Net Zero Teesside Project

The Net Zero Teesside Order

Document Reference: 9.21 Notification of Further Proposed Changes and Update on Remaining Optionality

Date: July 2022

TITLE
NOTIFICATION OF PROPOSED CHANGES OVERVIEW

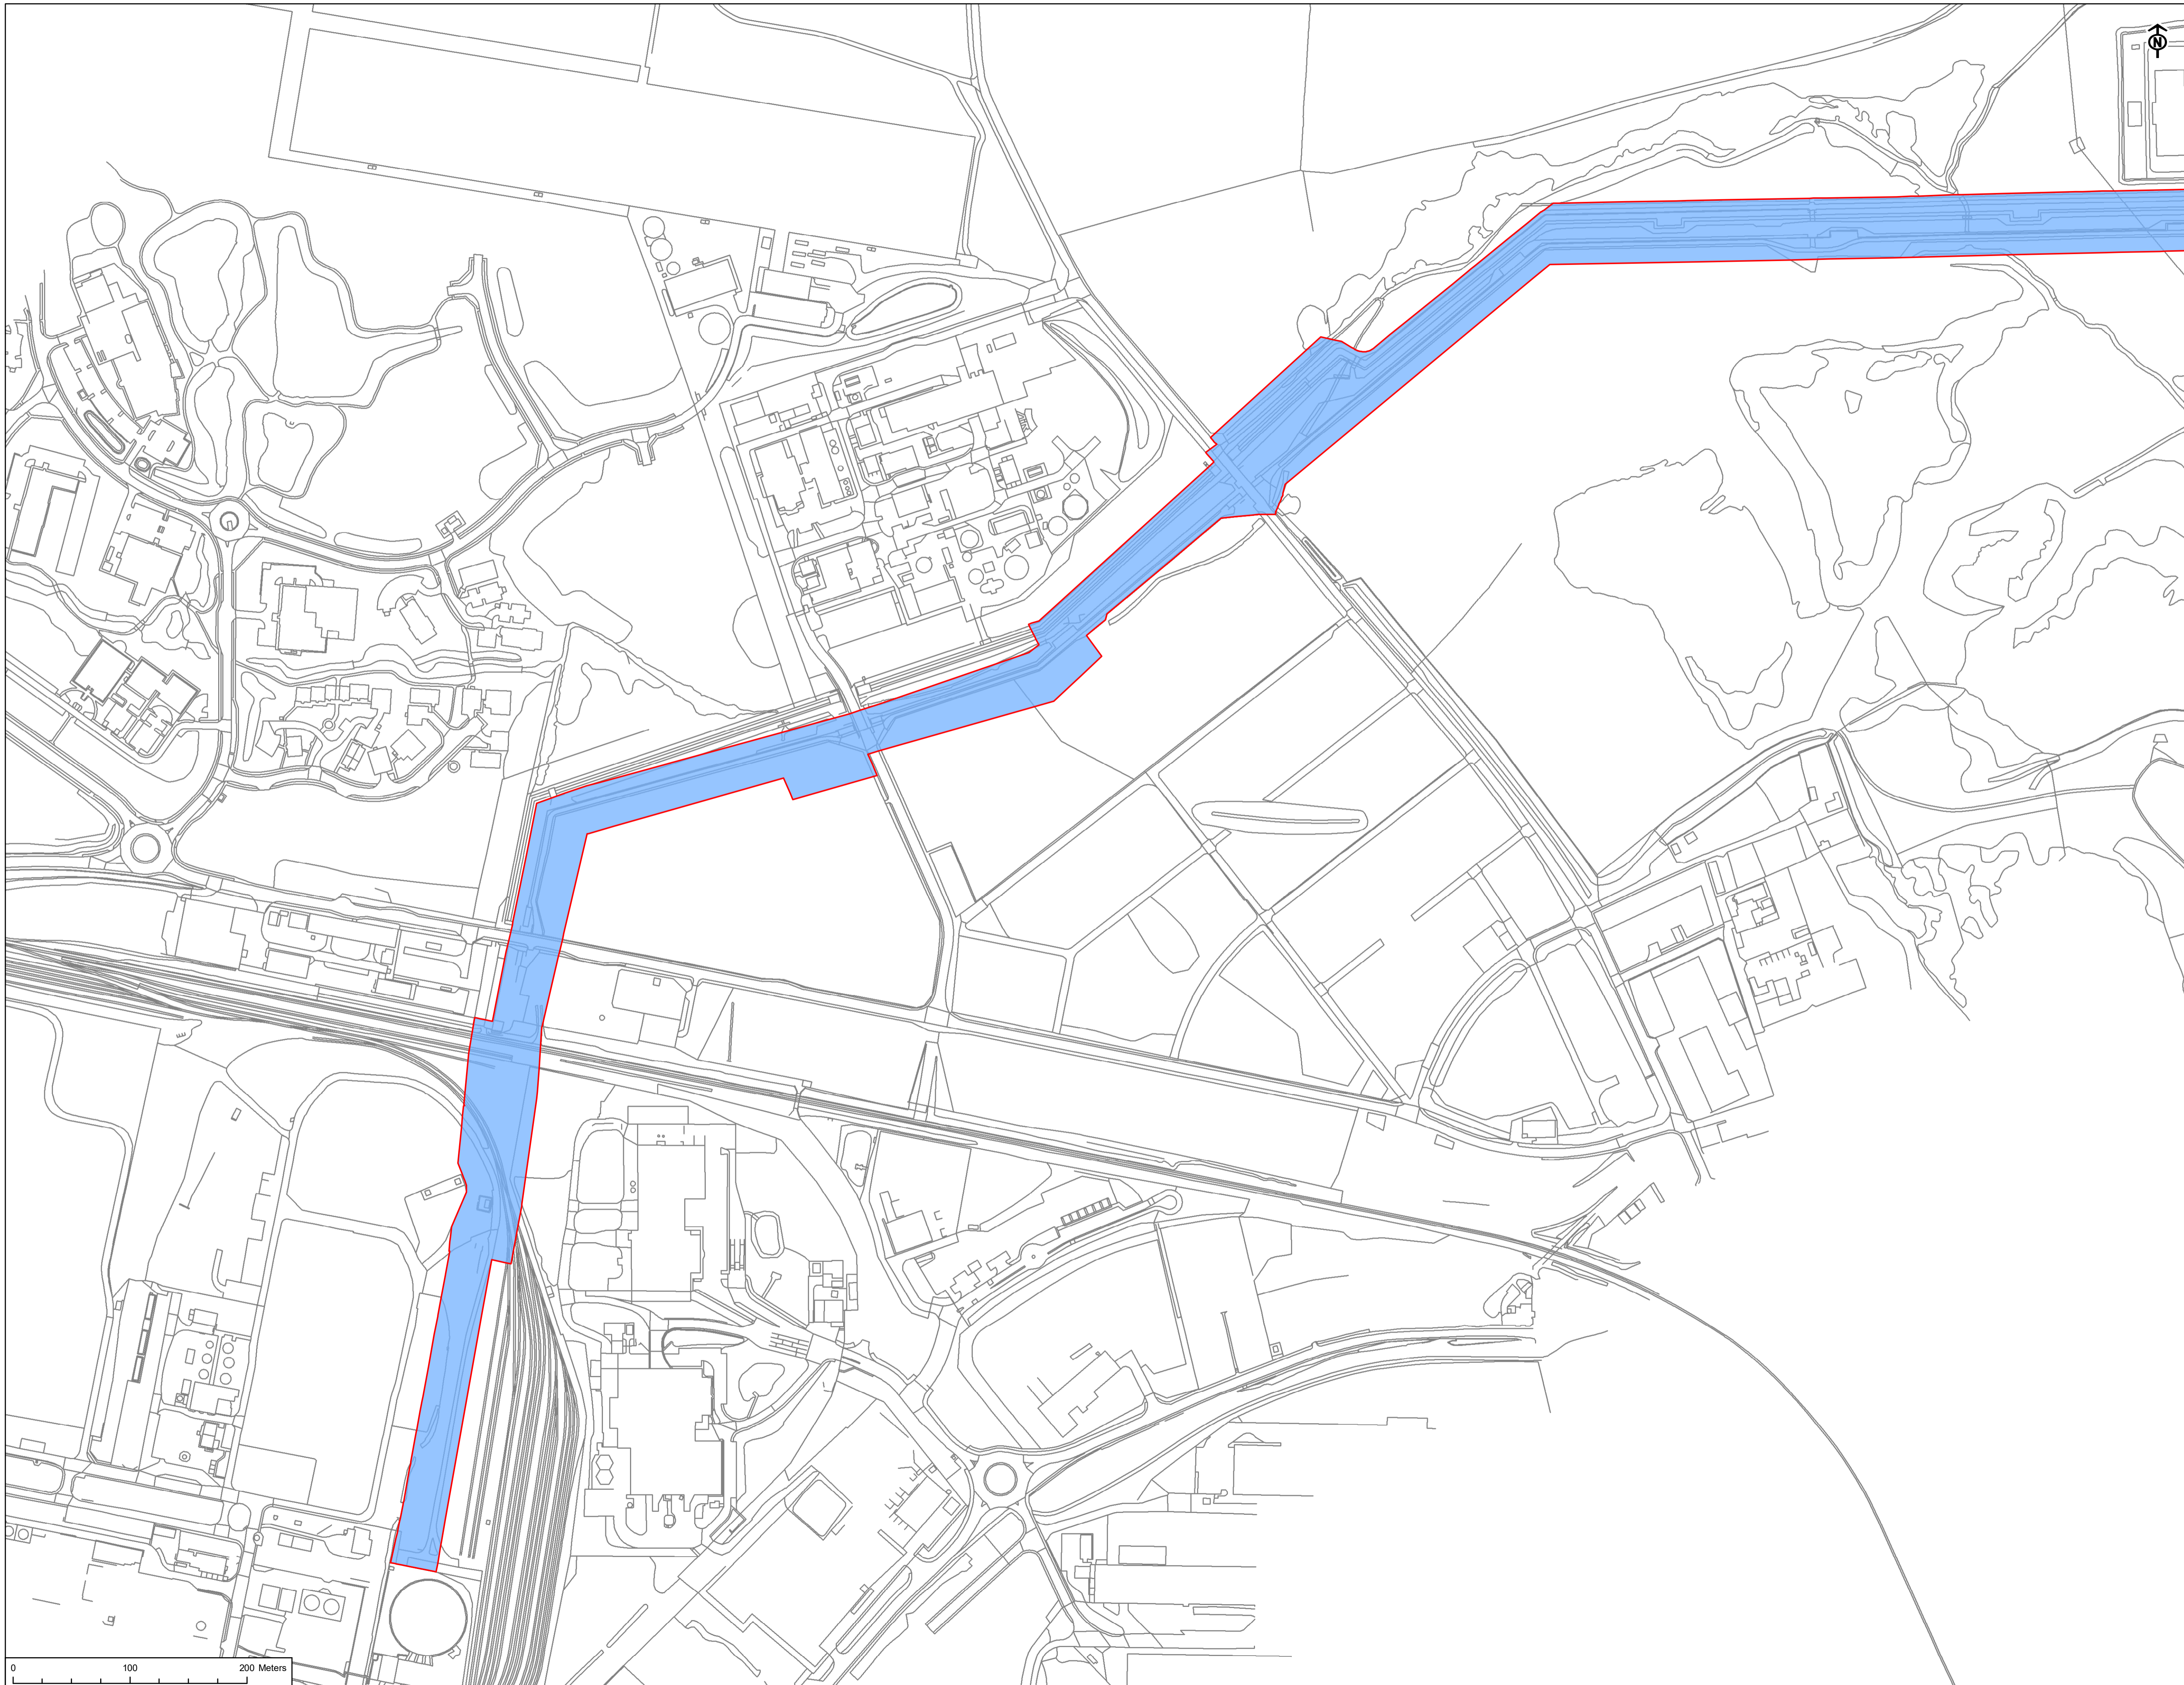
- 2.3.5 The Applicants propose to select Option 3 (Sembcorp Tunnel) and remove Option 2 (horizontal direction drilling) from the draft DCO.
- 2.3.6 The removal of Option 2 will have a beneficial impact of reducing the land requirements for the Proposed Development on both North and South Tees. These areas are shown on the indicative plans at Appendix 1.

- 2.3.10 Following continued landowner engagement and design development, the Applicants have identified areas of temporary possession land that can be removed from the Order Limits.
- 2.3.11 These proposed reductions have been assessed by the Applicants to ensure that the Proposed Development could be delivered subject to the use of compulsory acquisition powers.
- 2.3.12 These proposed changes have been shared with the relevant land owners in advance of Deadline 4. These areas are shown on the indicative plans at Appendix 1.

- 2.4.1 The proposed changes set out in Section 2.3 above are described below in terms of changes to the individual Work Number (Nos.) listed at Schedule 1 'Authorised Development' of the draft DCO (Document Ref. 2.1) and shown on the Works Plans (Document Ref. 4.4). The Applicants are proposing 4 changes in total which are summarised in Table 2.1 below. The reductions in the Order limits are shown on the plans at Appendix 1.

Change No.	Description
14	Removal of optionality for the CO ₂ Gathering Network by removal of Option 2 (horizontal directional drilling) resulting in a reduction in the Order Limits. (Work Nos. 6 and 9B).
15	Removal of optionality for the Electrical Connection by removal of Option 1B, resulting in a reduction in the Order Limits (Work No. 3A).
16	Removal of parcels of land from North Tees Land Limited land as they are no longer necessary following landowner discussions and technical assessment (Work No. 6).
17	Removal of parcels of land from STDC land as they are no longer necessary following landowner discussions and technical assessment (Work No. 9A).
